Project T10/1711-D

Information technology - SCSI / ATA Translation (SAT)

Summary of Comments on SCSI / ATA Translation Standard

Figure 2 — ATA document structure

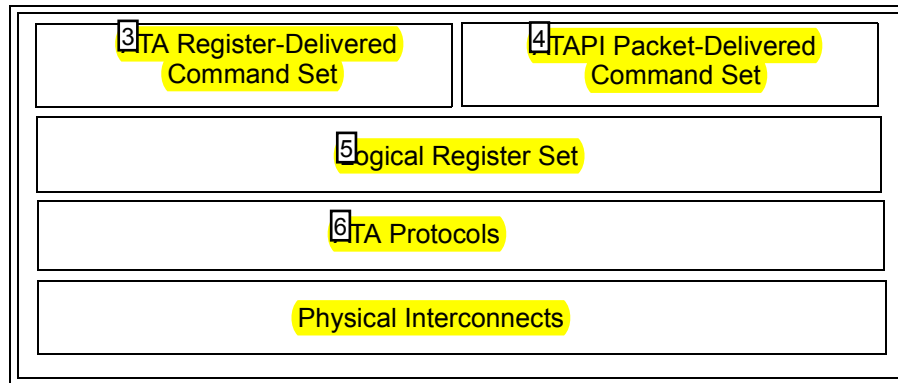
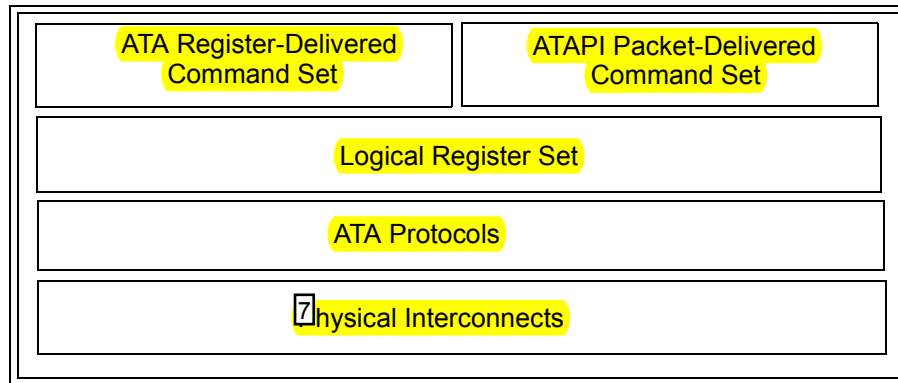
T In Figure 2

change
"ATA Register-Delivered Command Set"
to
"ATA register delivered command set"

T In Figure 2

Figure 2
change
"Logical Register Set"
to
"ATA logical register set"
RESOLUTION: Delete the box containing "Logical Register Set" as it doesn't appear in ATA/ATAPI-7.

T Figure 2

change
"ATA Protocols"
to
"ATA Transport Protocols"

T Figure 2
change
"Physical Interconnects"
to
"ATA physical interconnects"

change
"ATAPI Packet-Delivered Command Set"
to
"ATAPI packet delivered command set"
RESOLUTION: s/b "ATAPI packet delivered command sets", for consistency with ATA/ATAPI-7.

Figure 3 — SCSI/ATA translation document role

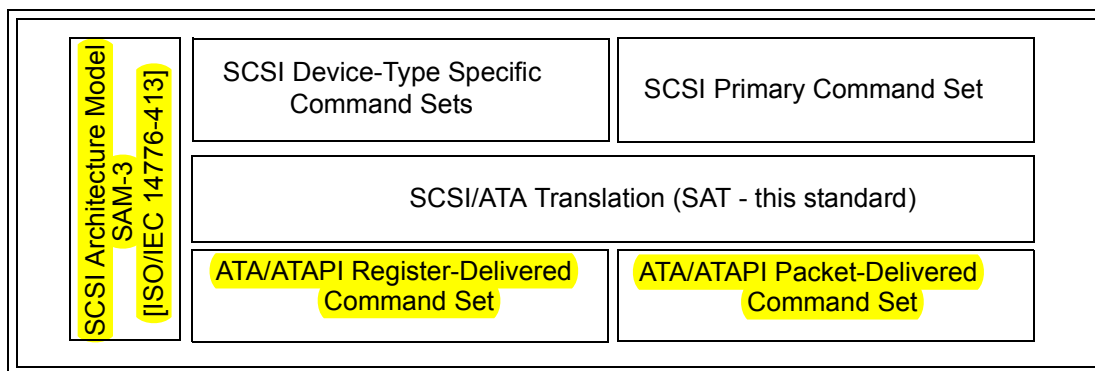
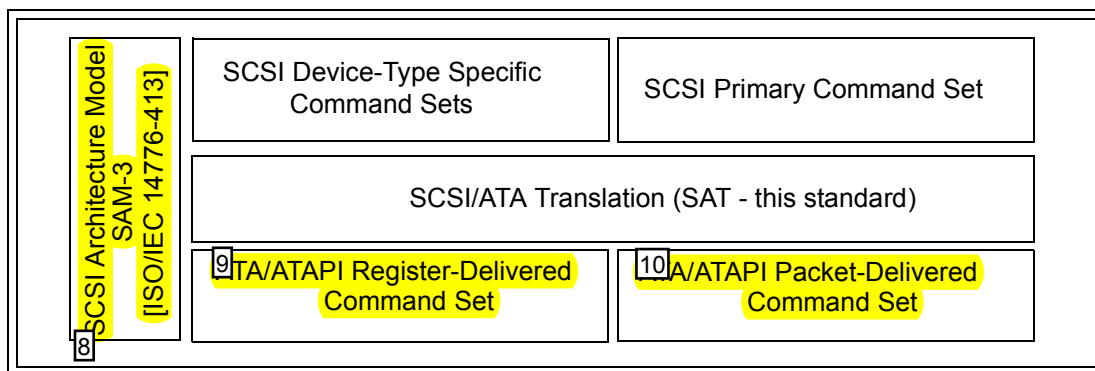
T In Figure 3, remove

T In Figure 3
change
"ATA/ATAPI Register-Delivered Command Set"
to
"ATA/ATAPI register delivered command set"

T In Figure 3
change
"ATA/ATAPI Packet-Delivered Command Set"
to
"ATA/ATAPI packet delivered command set"

or add versions to other boxes.
RESOLUTION: Delete "SAM-3 [ISO/IEC 14776-413]"

Figure 4 — SATL functional protocol reference model

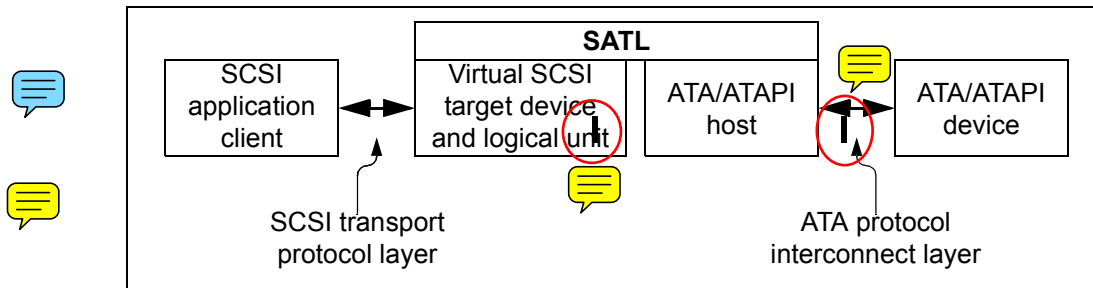
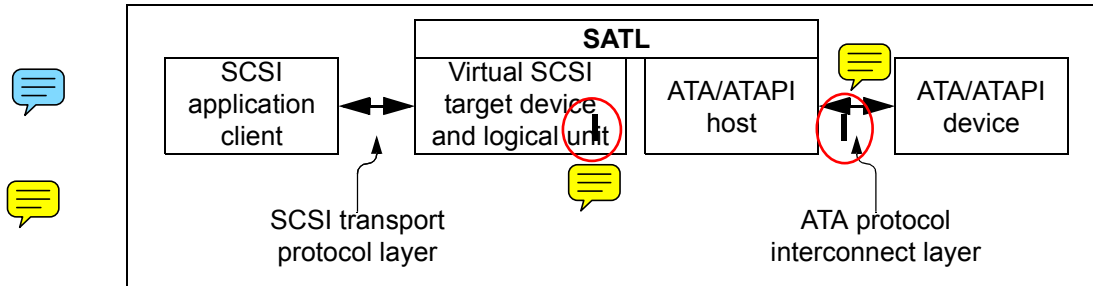
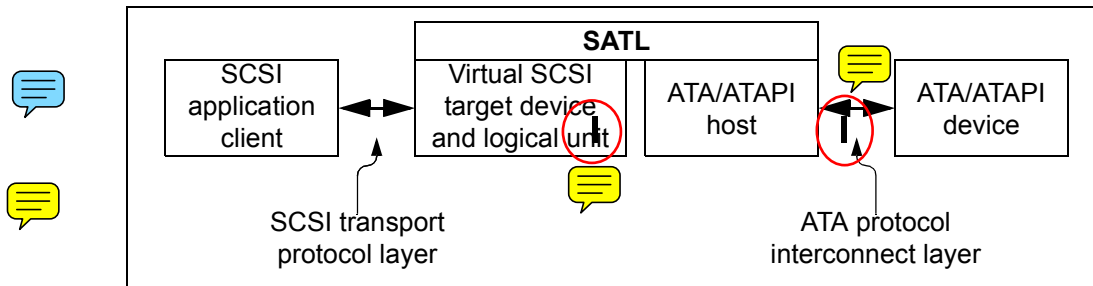
5.1 [SCSI architectural elements] Overview, first paragraph: change to, "Clause 5 defines SCSI/ATA translation elements that impact the representation of the storage domains defined in SAM-3 and ATA8-AAM. Figure 4 shows a SATL connecting a SCSI application client to an ATA/ATAPI device.

1. Remove what look like change bars in Figure 4
2. Change "logical unit" to "logical unit(s)"
3. Change "ATA protocol interconnect layer" to "ATA transport protocol interconnect layer"

5.1 [SCSI architectural elements] Overview, second paragraph: delete the first sentence ("Figure 4 shows a SATL connecting a SCSI application client to an ATA/ATAPI device.") as it is now included in the paragraph before the figure based on the previous comment. Change the remaining sentence to, "The SATL accomplishes this connection by:"

Figure 5 — Identification descriptors included by a SATL in an ATA host

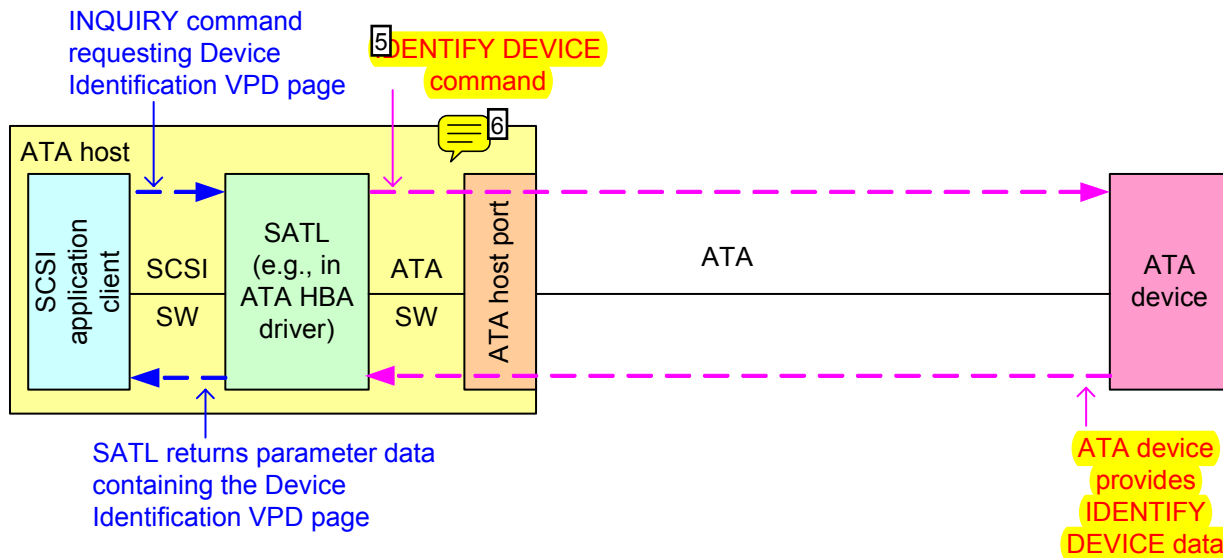
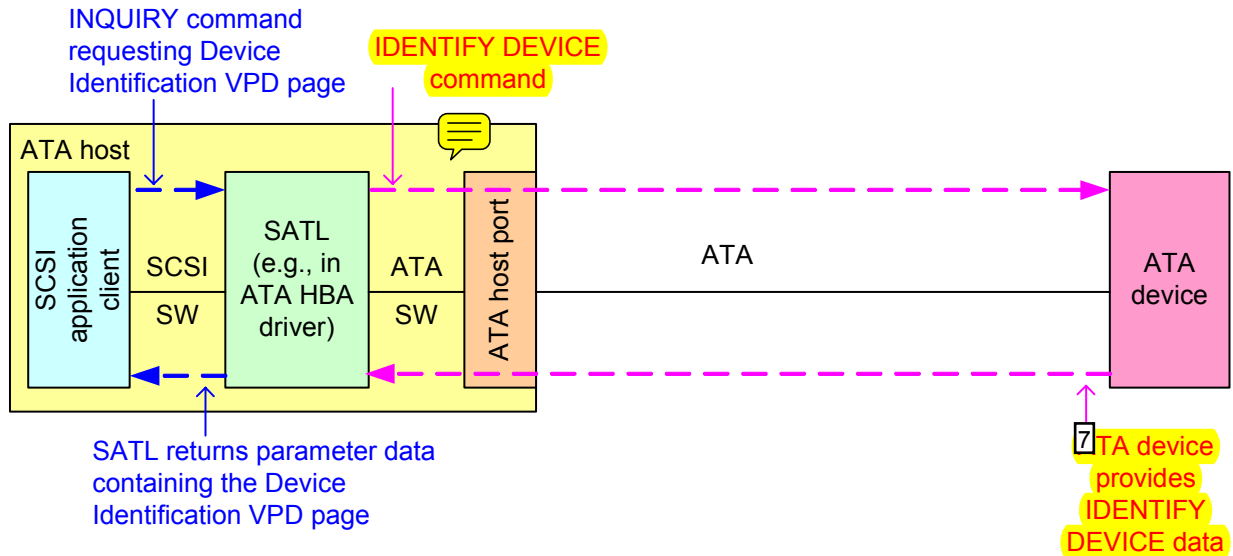
T In **Figure 5** — Identification descriptors included by a SATL in an ATA host
change

T In **Figure 5 — Identification descriptors included by a SATL in an ATA host**
change
"ATA device provides IDENTIFY DEVICE data"
to
"ATA device returns ATA IDENTIFY DEVICE data"

Figure 6 — Identification descriptors included by a SATL in a SAS initiator device

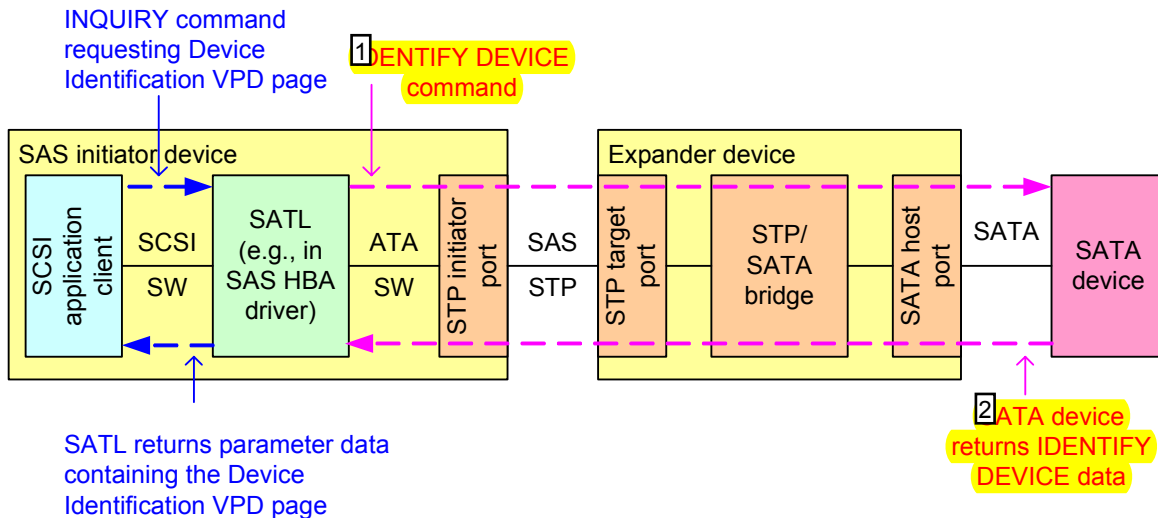
T In **Figure 6 — Identification descriptors included by a SATL in a SAS initiator device**

T In **Figure 6 — Identification descriptors included by a SATL in a SAS initiator device**

Figure 7 — Identification descriptors included by a SATL in a SCSI to ATA protocol bridge

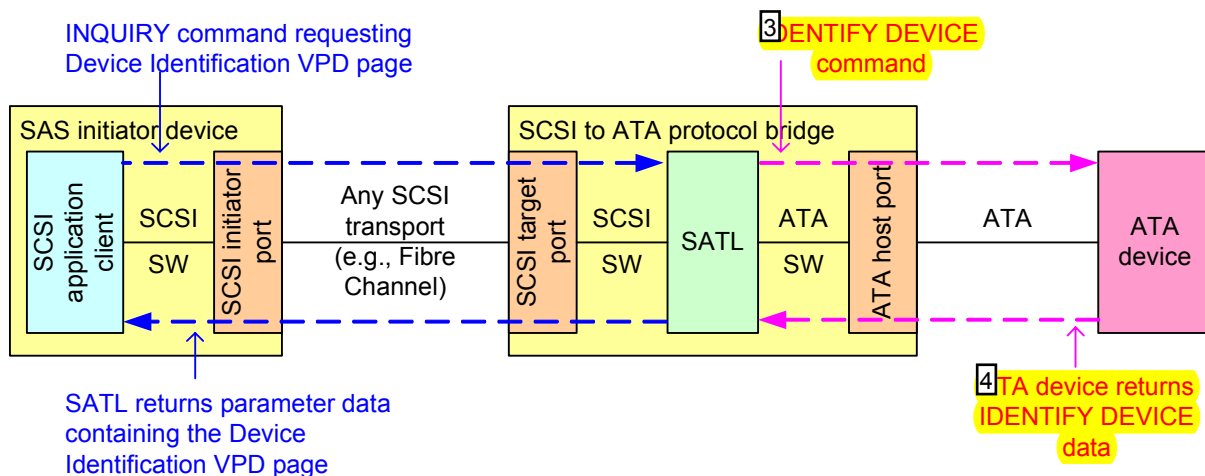
T In **Figure 7 — Identification descriptors included by a SATL in a SCSI to ATA protocol bridge**
change
"IDENTIFY DEVICE command"
to
"ATA IDENTIFY DEVICE command"

T In **Figure 7 — Identification descriptors included by a SATL in a SCSI to ATA protocol bridge**
change
"ATA device returns IDENTIFY DEVICE data"
to
"ATA device returns ATA IDENTIFY DEVICE data"
